Model 2450 System SourceMeter®

Version v1.1.0s Firmware Release Notes

Version v1.1.0s Release

PR50774 Models affected:

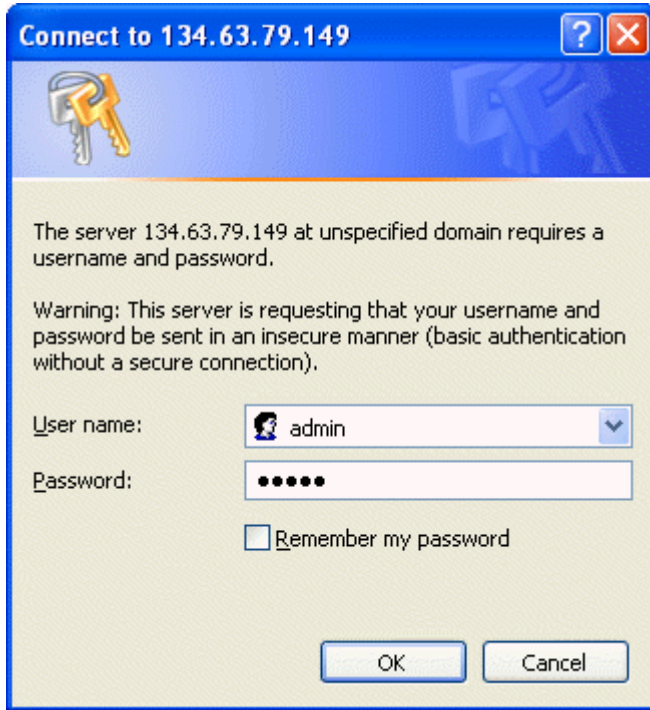
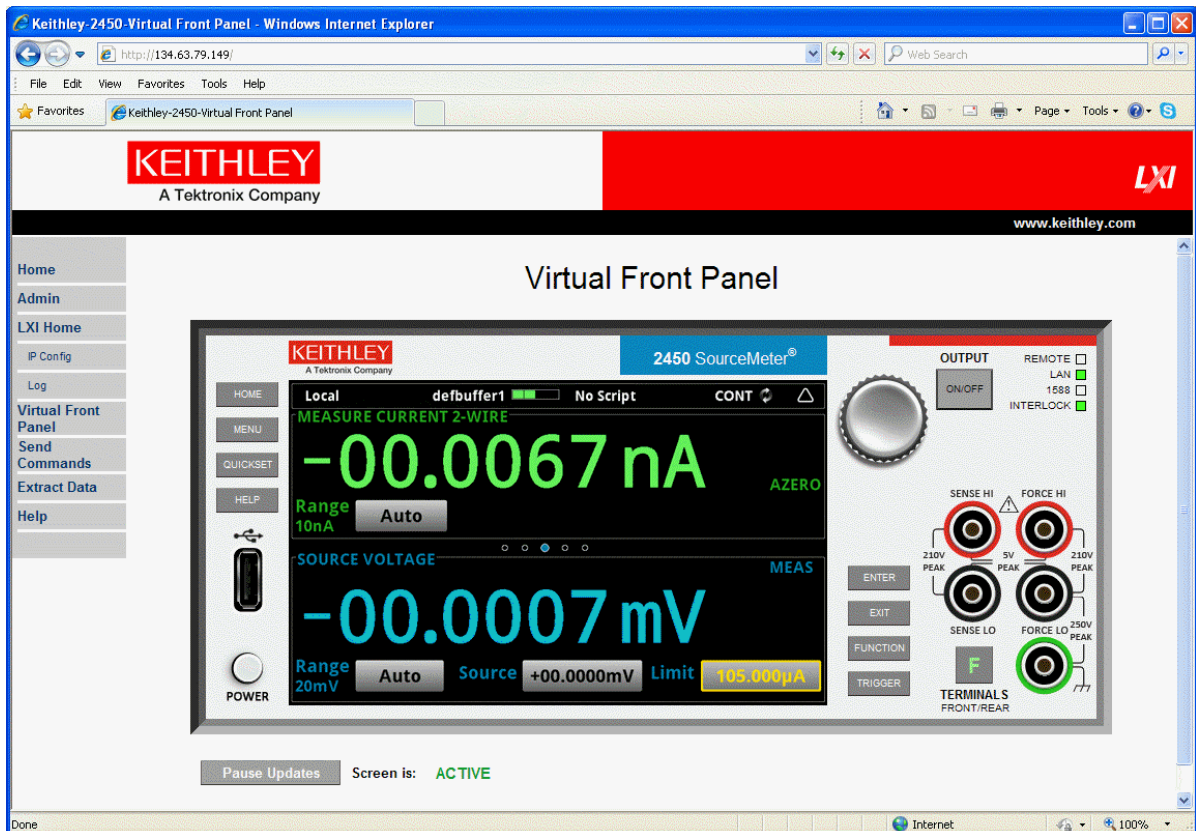
Implement new Virtual Front Panel capability.

To access the new Virtual Front Panel, access the 2450 through Ethernet using your favorite Internet browser.

When asked for a Username and Password: enter the Username and Password for that particular 2450. The default Username is admin and the default Password is admin.

An example of the 2450 Virtual Front Panel is shown below. Users can use their mouse from a standard PC to control the instrument. Users can also use touch screens from most touch screen devices that can access the 2450 IP address.

PR50876 Models affected:

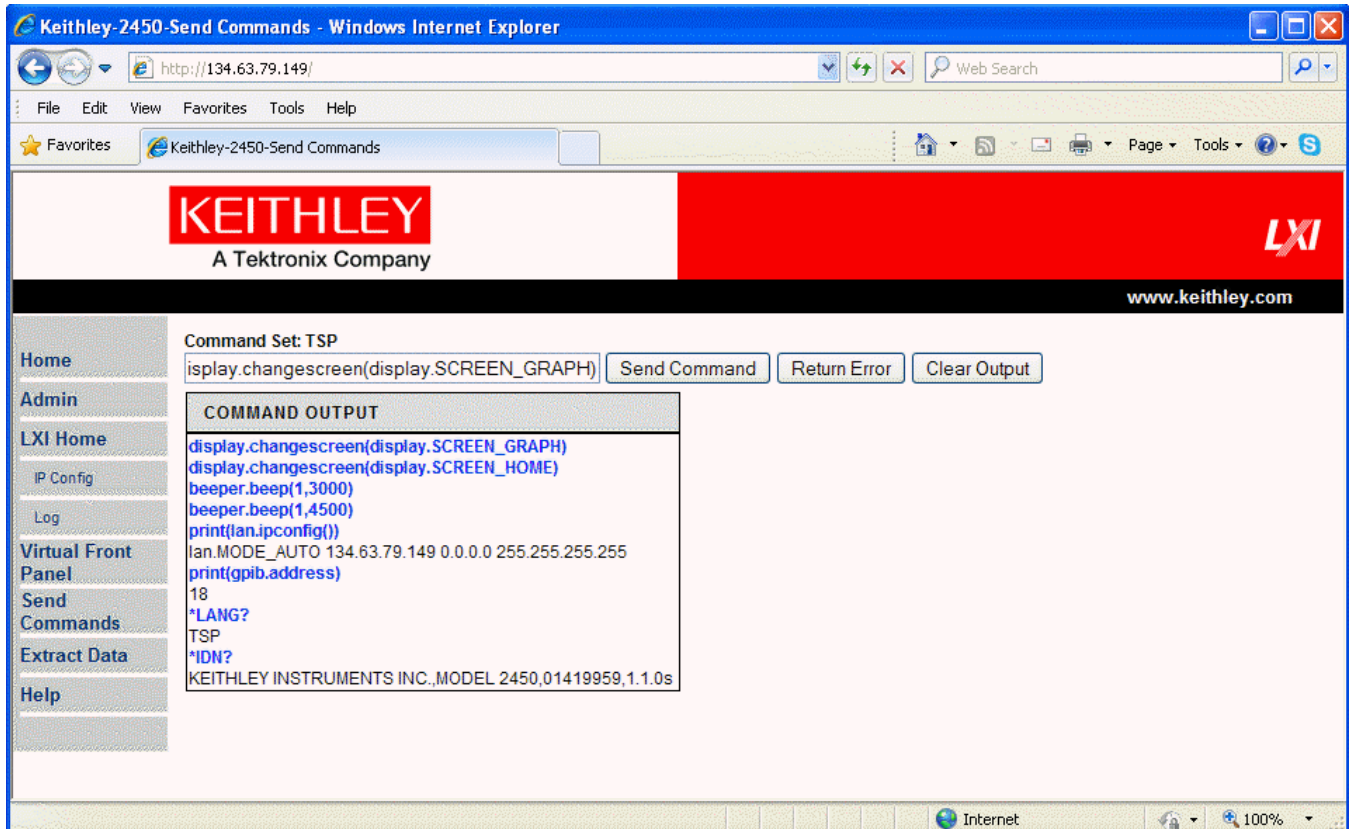
The behavior of the *LANG? command on the 2450 has been changed as follows.

Sending the query *LANG? over a non-controlling interface will no longer change the interface control of the unit. For example, if the unit is under local control, then sending the *LANG? over Telnet, USB, or GPIB will leave the unit under local control. This was done in order for KickStart (or any other remote control software) to query connected/accessible instruments without resetting them or changing or disturbing the current trigger model.

PR49892 Changes to the Reference Manual.

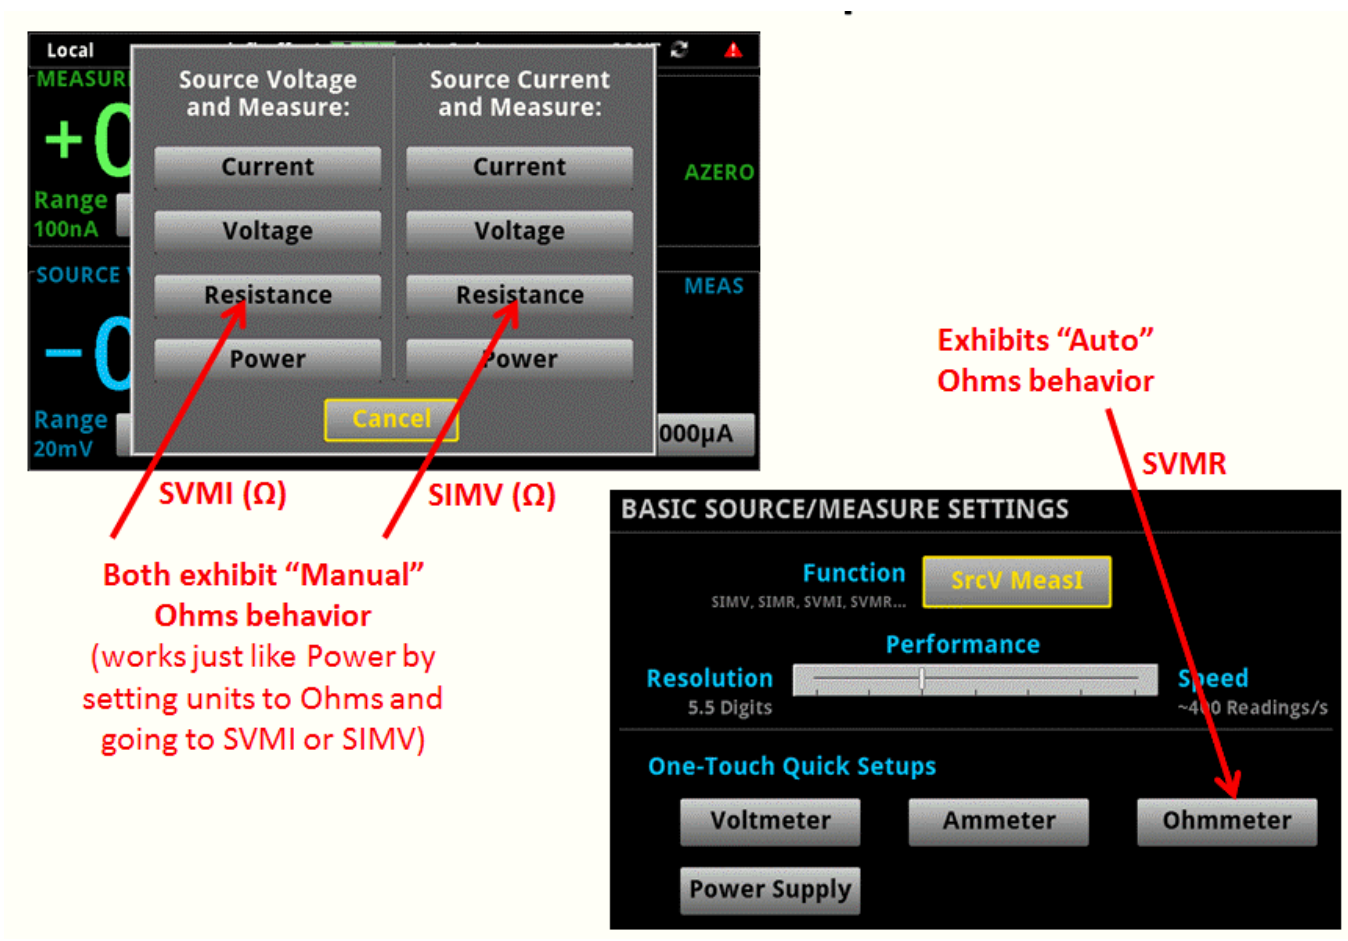
D) Resistance Mode Changes: Auto Ohms vs. Manual Ohms:

- b. The term “Auto Ohms” has been removed from the user interface. The user interface now presents “Ohmmeter” as a One-Touch Quick Setup (see diagram below).

- c. The term “Manual Ohms” has been removed from the user interface. The user interface now presents “Resistance” as a Measure function vs. Voltage or Current Source (see diagram below).
